Access Compliance Report

Public Rights-of-Way

(Curb Ramps)

Intersection ID: 43685	Main Street: HARLINGTON_LN	Cross Street: TODDINGTON_LN	Location: SW
ADA ID: 9AB5833549F2	Ramp Type: PerpDiag	Initial Pass/Fail: Fail	Overall Compliance: No
Severity Score: 10			
Codes/Mitigation Info/Possible Solution		Field Measurements/Component Compliance

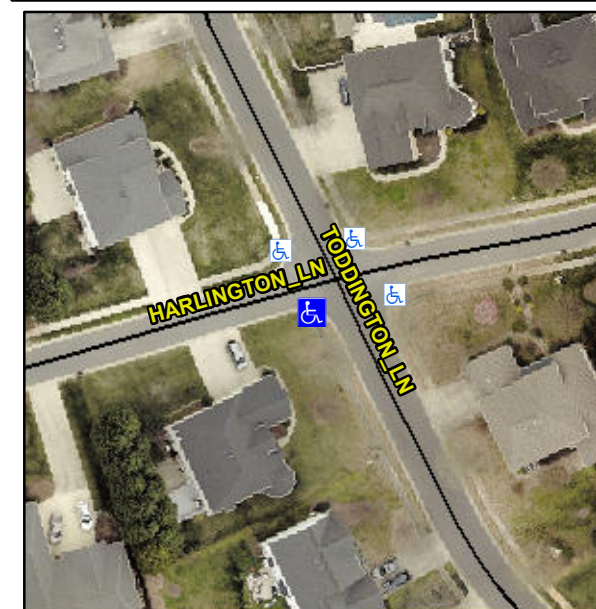
Not Found, R304.5.1, R304.5.3

Compliance	Description	Data	Compliance	Description	Data
N/A	Ramp Length (in)	43.0	Yes	Ramp Slope (%)	5.6
No	Ramp Width (in)	47.0	No	Ramp XSlope (%)	4.1
N/A	Flare Type LT	N/A	N/A	Flare Type RT	N/A
N/A	Flare Slope LT (%)	N/A	N/A	Flare Slope RT (%)	N/A
N/A	Flare Traversable LT?	N/A	N/A	Flare Traversable RT?	N/A
N/A	Landing Length (in)	N/A	N/A	DWS Provided?	N/A
N/A	Landing Width (in)	N/A	N/A	DWS Contrast?	N/A
N/A	Landing Slope (%)	N/A	N/A	DWS Length (in)	N/A
N/A	Landing X Slope (%)	N/A	N/A	DWS Full Width?	N/A
N/A	Landing Curb? (Y/N)	N/A	N/A	DWS Offset (in)	N/A
N/A	Shared Landing?	N/A			
N/A	Gutter Ponding?	N/A	N/A	Gutter Slope (%)	N/A
N/A	Gutter Lip Ht (in)	N/A	N/A	Gutter X Slope (%)	N/A
N/A	Painted X Walk1?	No	N/A	Painted X Walk2?	No
	X Walk 1 Direction	To E		X Walk 2 Direction	To N
N/A	X Walk 1 Width (in)	N/A	N/A	X Walk 2 Width (in)	N/A
	X Walk 1 Slope (%)	3.7		X Walk 2 Slope (%)	0.8
	X Walk 1 X Slope (%)	0.8		X Walk 2 X Slope (%)	2.4

Remove & Replace Curb Ramp With Two New Directional Ramps or Equivalent.
